CHANGE ORDER NO. # 3

Project Engineering Services for Vernon Hills NCT WWTP Improvements . (PO# 107202)

Re: NCT - Existing Sand Filters 1 & 2
Concrete Repair and Plant Water Pump Support Frame
RHMG Project No. 21102030

PARTIAL PLAN - EX. SAND FILTERS 1 & 2
N.T.S.

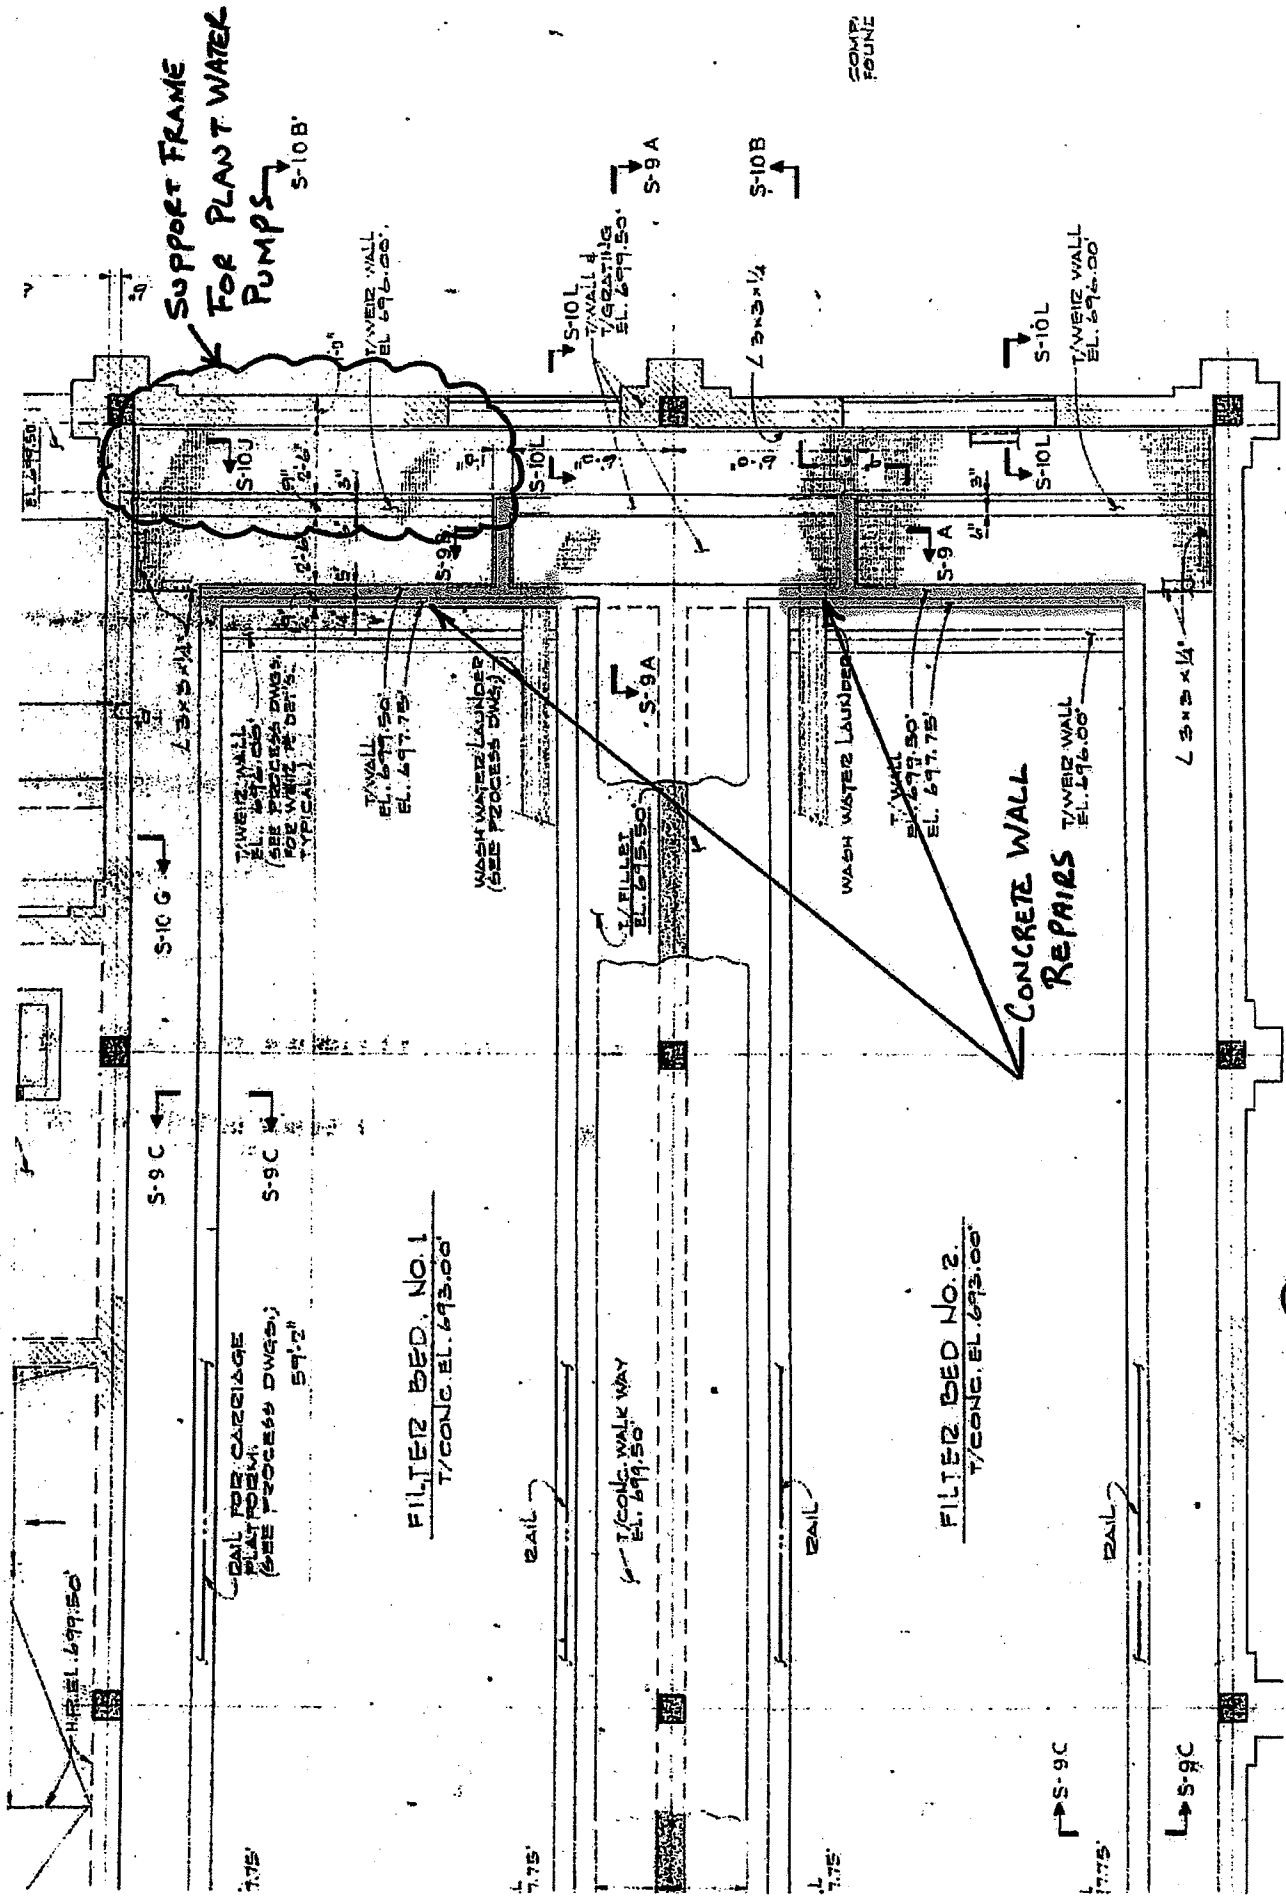
Based on our review of the existing conditions and available record drawings, it is our recommendation that the following repairs be made. Remove the top 1'-9" of the effluent channel walls (the 5" thick portion of the walls), redesign the reinforcing steel and concrete for a new wall to be constructed at a thickness of 9-inches, new steel embedment for the grating support, installation of new handrail mounts, removal of the plant water pumps for the demolition of the support frame, and the redesign of the steel support frame for the plant water pumps. The configuration of the new support frame will be similar to the existing so that the on-site grating can be reused. The concrete repair work for the effluent channels and replacement of the steel support frame for the plant water pumps is interrelated and the work needs to be sequenced with the plant's sludge dewatering operations. A shutdown of the plant water system will be necessary to perform the repair work.

- Demolition plan for the removal of the top 1'-9" portion of the concrete channel wall (5" thick portion of the wall). Please see attached figure.
- Demolition plan for the removal of plant water pumps and steel frame.
- Design of new steel reinforcing for the new 9-inch wall.
